**ALTERATION OF A LOCAL HISTORIC DISTRICT (LHD) PROPERTY**  
**STAFF REPORT**

**Site:** 57 Columbus Avenue

**Case:** HP23-000051

**HPC Meeting Date:** March 19, 2024

Above: HPC approved plans in 2012, right elevation

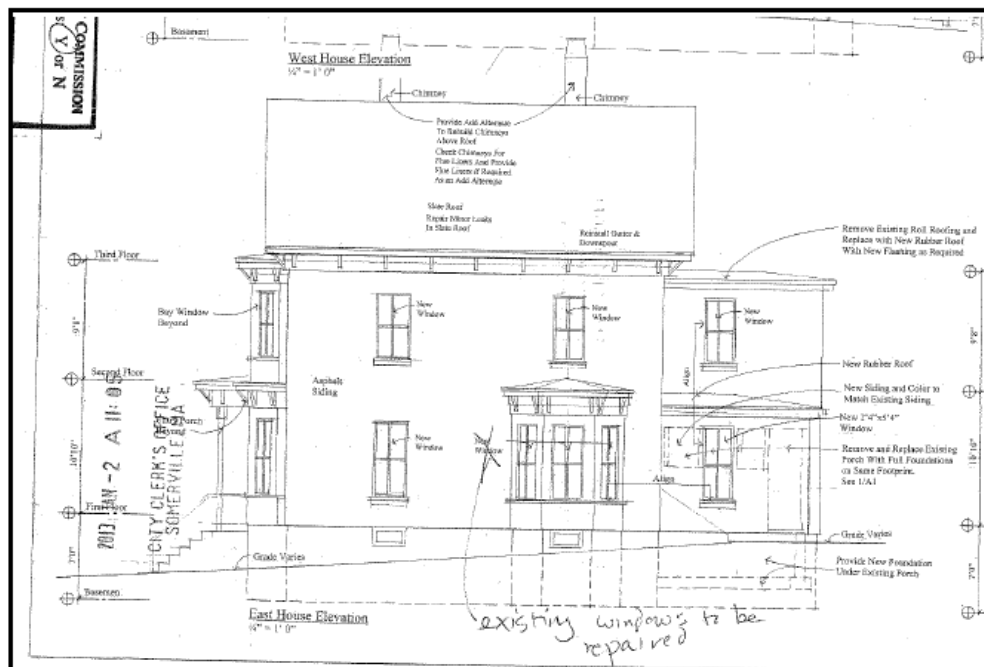
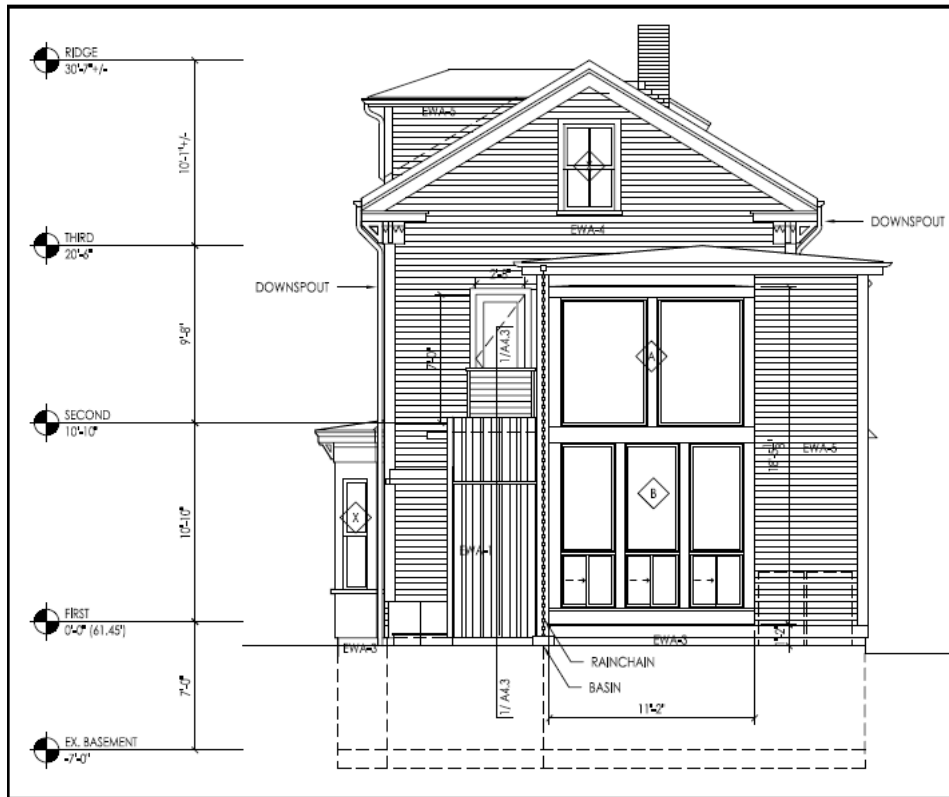
It is important to note that all portions of the structure are visible from a right-of-way given that Prospect Park is located behind the property. Parks are considered a public right-of-way. While the Applicant made an effort not to copy the historic structure exactly by using the vertical clapboards and square windows, these will distract from the historic building by drawing passerby’s eye to the addition. The siding should use wood horizontal clapboard that has the same reveal as the rest of the structure. The picture window overlooking the railing should be one or two double hung sash windows with a 2/2 design. The railing should utilize wood in a turned wood style. The addition will be differentiated from the rest of the structure through the lack of detailing below the eave line. Preservation Staff has included conditions in Section IV ‘Recommended Conditions’ below regarding the use of wood clapboard.

6. Siding for the mudroom additional shall be horizontal wood clapboard to match the rest of the building's facades.
7. Replacement gutters shall be wrapped to match the portion of the building against which they rest.

*Above: Existing bay windows*

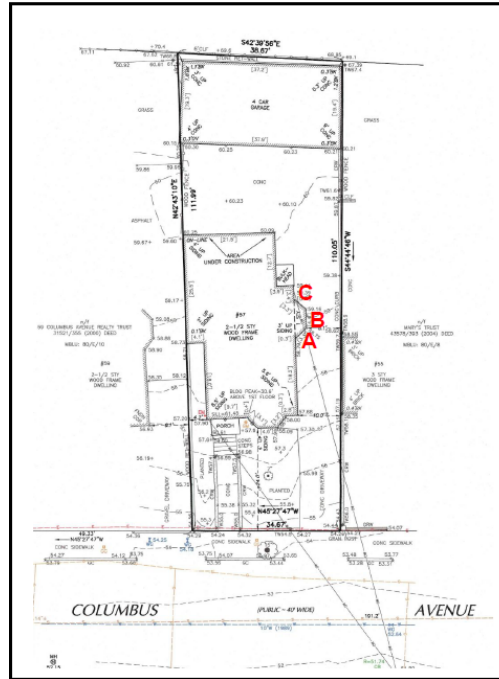
The original wood bay windows were applied to be replaced in 2012 but due to the condition and nature of these windows the HPC denied the request and instead conditioned the repair of these

windows. Per the Design Guidelines historic windows should be retained and repaired. Preservation Staff has included conditions in Section IV 'Recommended Conditions' below regarding the preservation and restoration of these windows.

10. Bay windows on the right elevation shall be restored.
11. Both brick chimneys shall be retained.
12. Any changes to this proposal made prior to the commencement of work or in-the-field changes shall be submitted to Preservation Planning for their review to determine if the changes come under the purview of the HPC.

*Above: Existing front door*

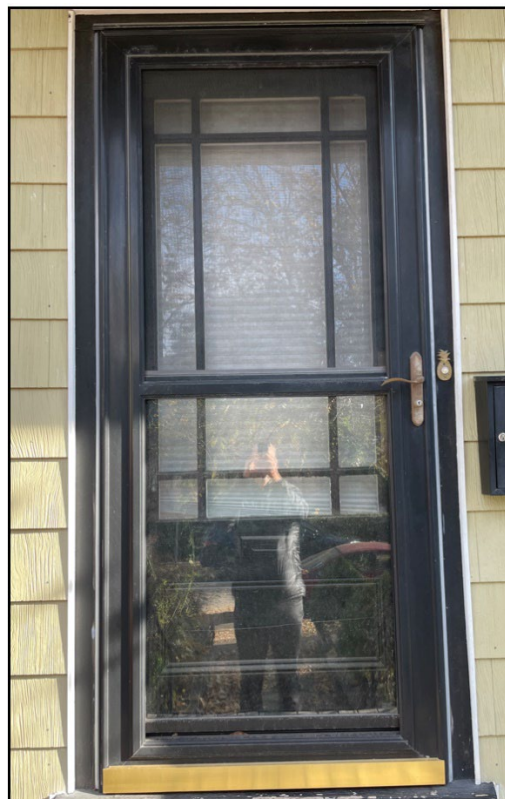
The Applicant is proposing to replace the wood front door with a replicated door ensuring the door will match the style and appearance of the building. This proposal was also approved in 2012 by the HPC.

**Option B:***Above: Proposed rear elevation*

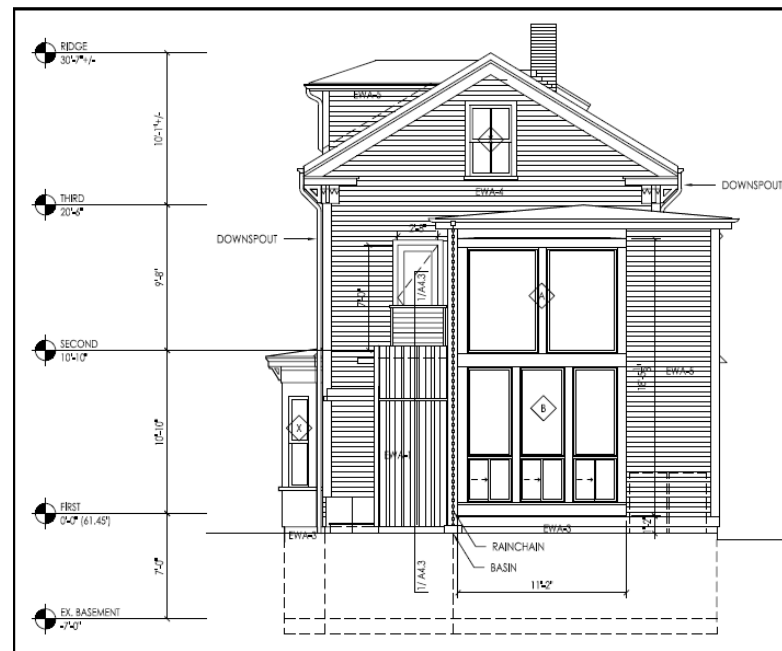
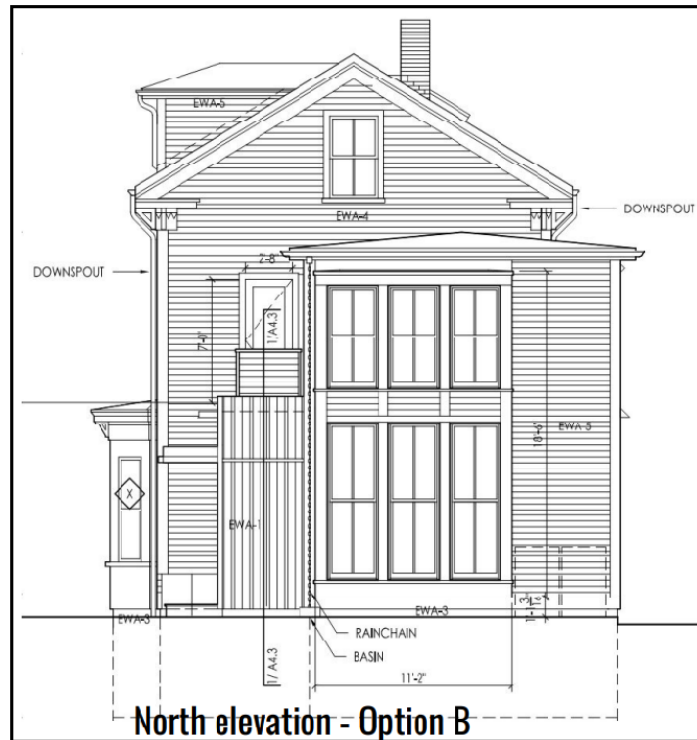
The proposed window installation on the rear of the property does not comply with the Historic Design Guidelines. It is important to note that all portions of the structure are visible from a right-of-way given that Prospect Park is located behind the property. Parks are considered a public right-of-way. Option A of the design is not consistent with the architecture and date of construction for 57 Columbus. Option B's window design is more appropriate for the style and architecture of the building. The inclusion of muntins and wood trim does make the windows depicted in Option B to look more consistent with the rest of the structure.

The proposed French glass door leading to the roof deck atop the mudroom and the door leading outside from the mudroom are not consistent with the style of the structure. Should the Commission approve the installation of these doors they should have an applied muntin grid to them with final design approved by Preservation Staff. Preservation Staff has included conditions in Section IV 'Recommended Conditions' below regarding these doors.

3. The front façade portico shall utilize wood steps, railings, landings, steps, and columns.
4. The door leading onto the rooftop deck shall utilize, raised profile muntins with final design to be approved by Preservation Staff.

5. The door leading from the mudroom addition to the side yard shall utilize, raised profile muntins with final design to be approved by Preservation Staff.

*Above: Detail of exposed wood clapboard below asbestos clapboard*

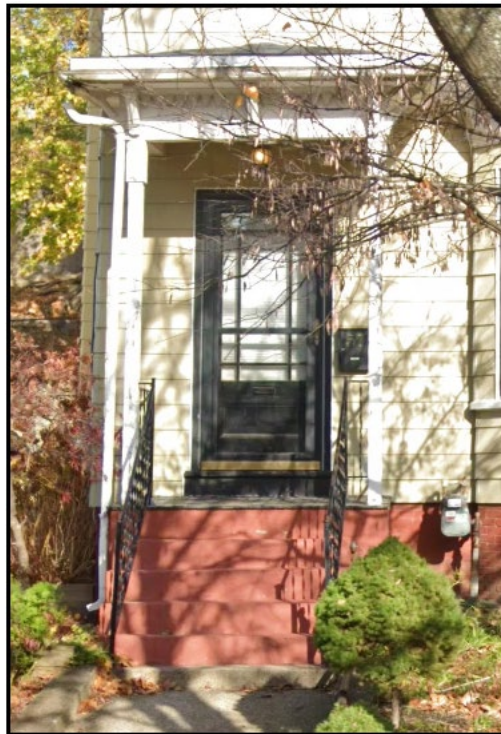
The proposed work does not comply with the above referenced section of the Design Guidelines as it will not only utilize cement fiber clapboard but will also remove wood clapboard and replace it with synthetic siding.

Ideally, the Applicant would assess the quality of the wood siding that is below the asbestos clapboard and repair the existing wood siding where possible, and repair, in-kind, those sections that cannot be repaired. However, should the Commission find the clapboard too deteriorated to repair and replace Preservation Staff recommends that the Applicant replace the extant clapboard with wood clapboard that matches the material, dimensions, and details of the current wood clapboard.

8. The replacement clapboard shall be made of wood.
9. Replacement siding shall reproduce the dimensions of the original clapboard, including its relationship to corner boards, window trim and other architectural details, all of which must be retained. The reveal must also be the same as that of the existing wood clapboarding.

*Above: Rendering of proposed portico*

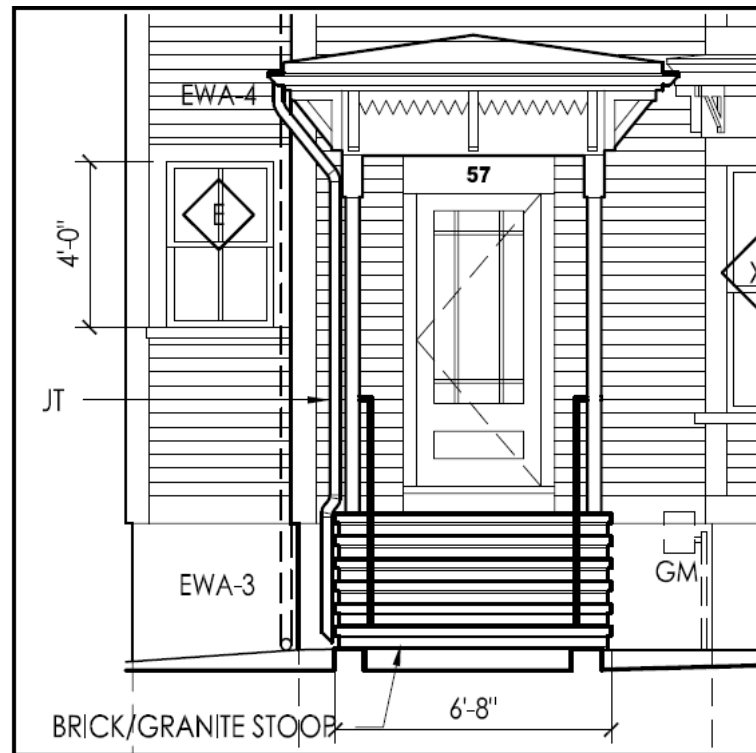
The proposed plan to rebuild the front portico with brick and granite does not comply with the above cited guideline. Given the time of construction and style, the portico would have been constructed from wood with a brick foundation. The Applicant should rebuild the portico utilizing wood. Preservation Staff has included conditions in Section IV ‘Recommended Conditions’ below regarding the portico.

*Above: Gutter sectional*

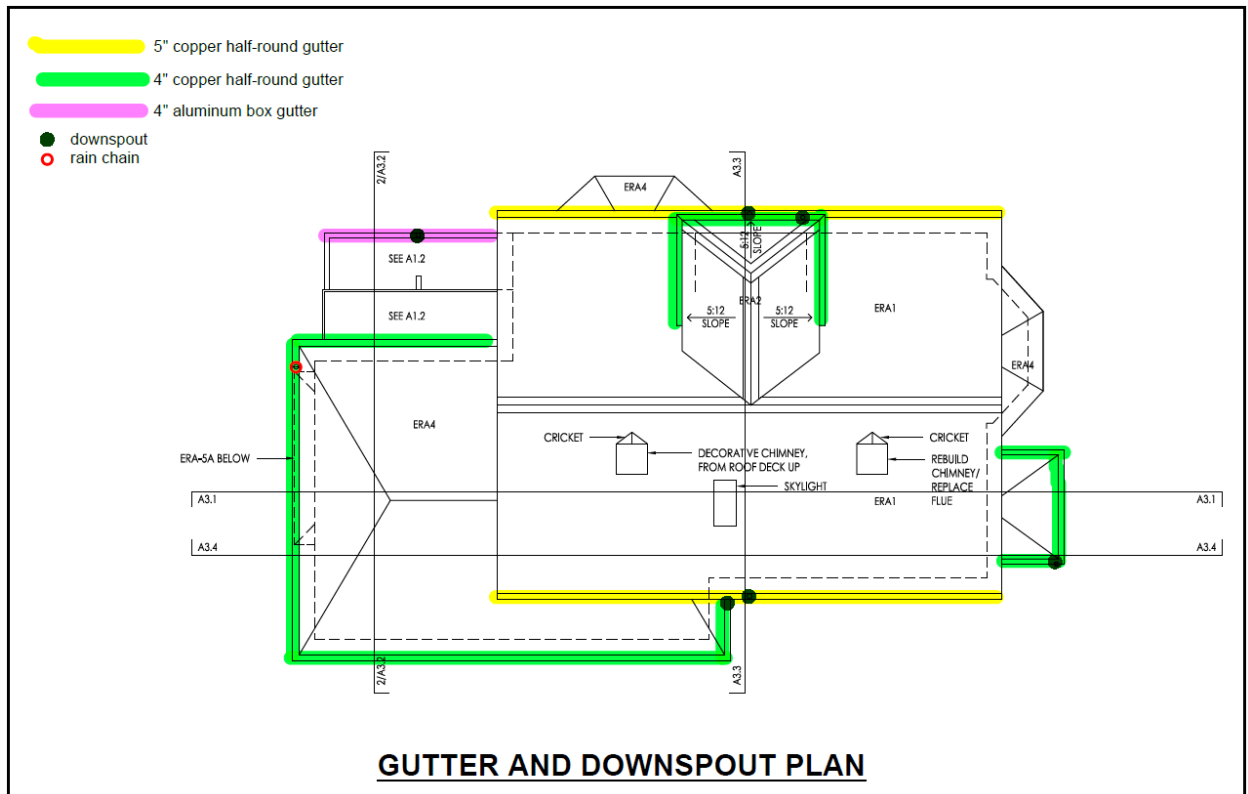
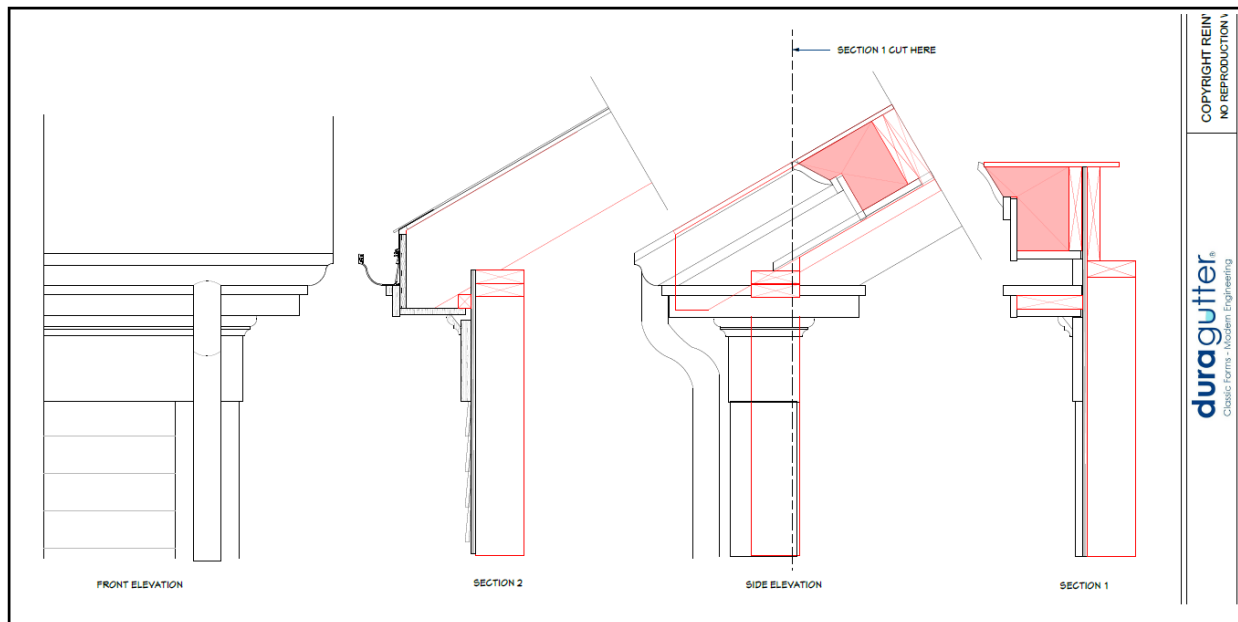
Due to the date of construction and style of architecture a wood gutter would be more historically accurate than a copper downspout. However, the current gutters and downspouts are replacements, and Duragutter gutters have been approved by the Commission on other properties.

Should the Commission approve this request, Staff recommends that the new gutters and downspouts be wrapped in such a way that they match the portion of the building against which they rest. Preservation Staff has included conditions in Section IV 'Recommended Conditions' below regarding the above noted concern regarding gutters.

*Above: Proposed right elevation showing proposed new dormer*

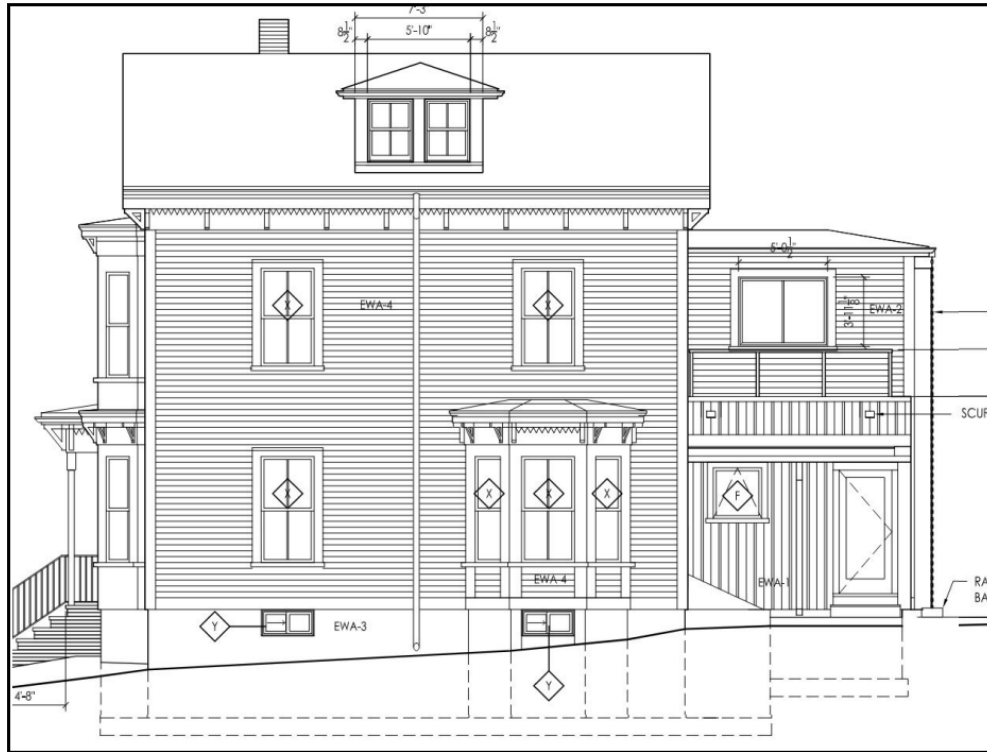
The proposed style of the dormer conforms with the above cited design guidelines as the window does match the style of architecture for the structure.
